## Groundwater Application Review Summary Form

Application # G- 18753

PUBLIC INTEREST REVIEW FOR GROUNDWATER APPLICATIONS

**A. GENERAL INFORMATION:** Applicant's Name: Otis Creek Ranch, LLC County: Harney

Water-Level Trends in Nearby Wells

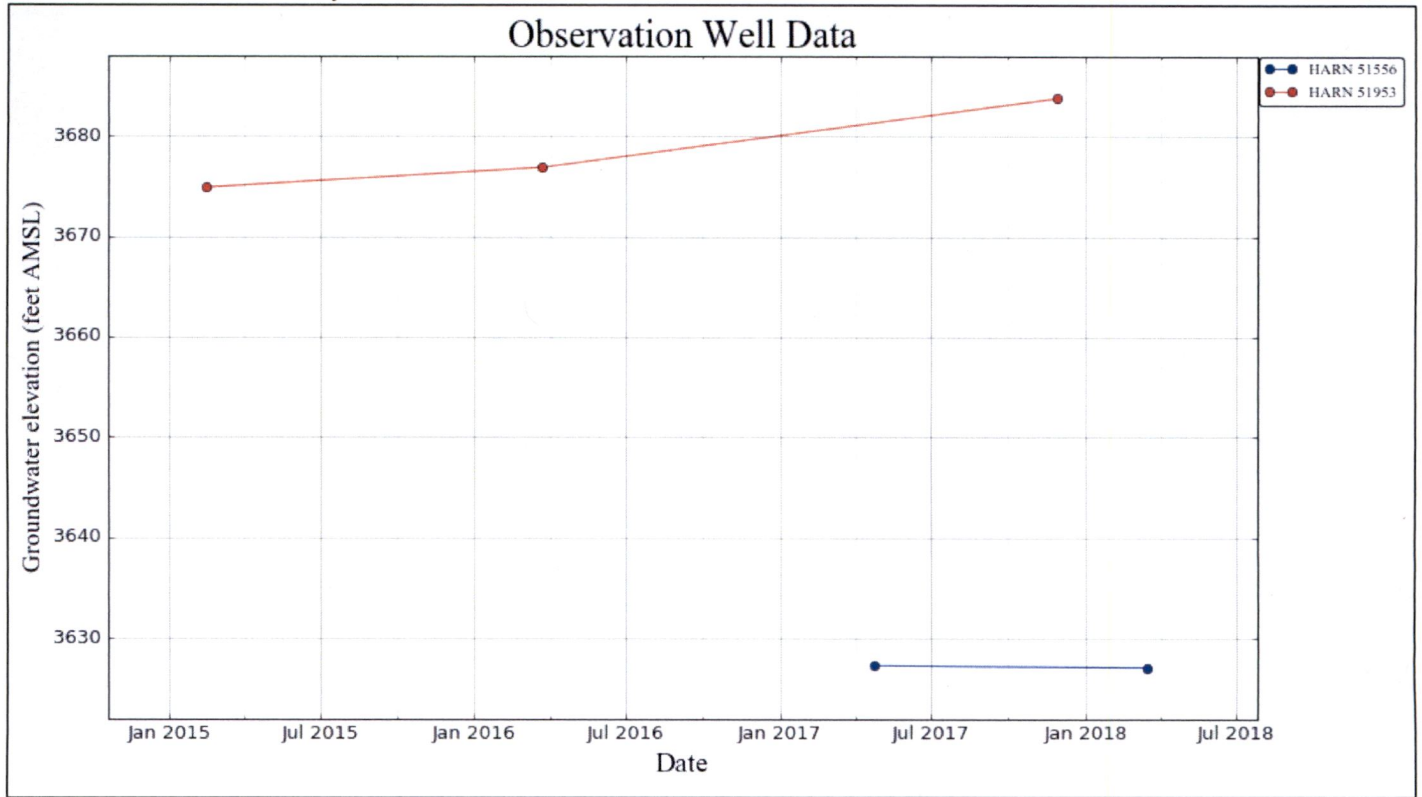
B3. **Groundwater availability remarks:** Considering available data, water levels do not show considerable, sustained declines. In the attached hydrograph, HARN 51953 (identical to proposed POA wells) reports stable water level elevations.

Nearby wells producing from deep water-bearing zones display stable water levels, but the record is very short.

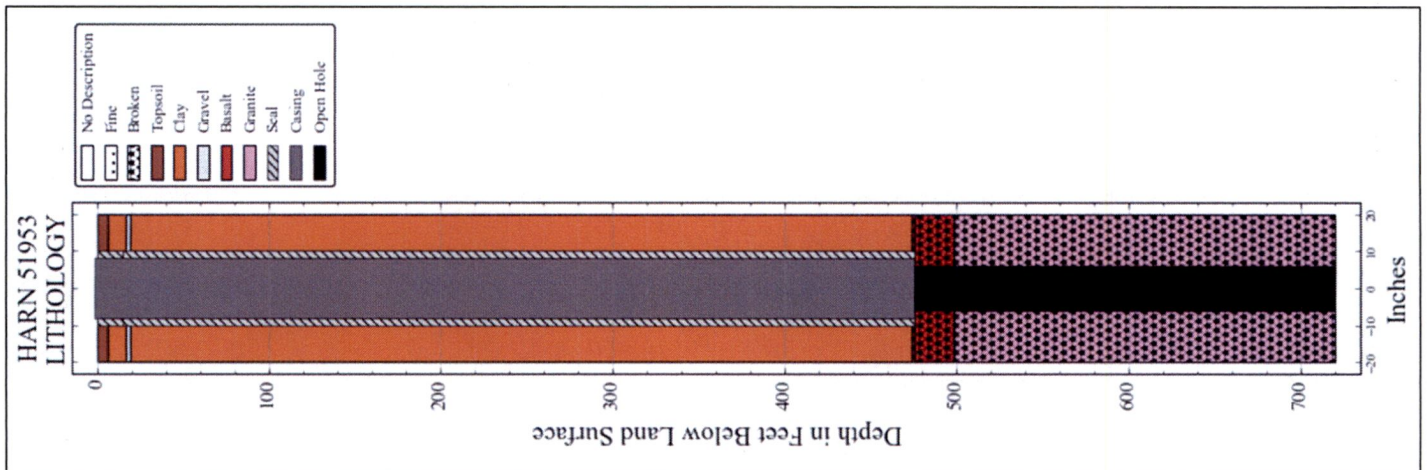
A4. **Comments:** Nearby HARN 51953 appears to be the model for the proposed well construction of each of the proposed POAs (see attached chart), and has been measured under permit condition from 2015-2017. The most recent measurement on 11/28/2017 produced a water level elevation of 3683.79' AMSL.

HARN 51953 reported lithology and construction diagram. Well is constructed to produce only from fractured basalt and intrusive volcanic rock at depth, with continuous case and seal through sedimentary sequence. Both POA wells on this application propose construction that is identical to this well.

C6. **SW / GW Remarks and Conditions:** If a permit is issued, POA wells shall be constructed to produce from only the fractured rock aquifer present at depths greater than 400' in most locations in this area, with continuous casing and seal placed through the overlying sedimentary sequence.  
\_\_\_\_\_  
\_\_\_\_\_  
\_\_\_\_\_  
\_\_\_\_\_  
\_\_\_\_\_
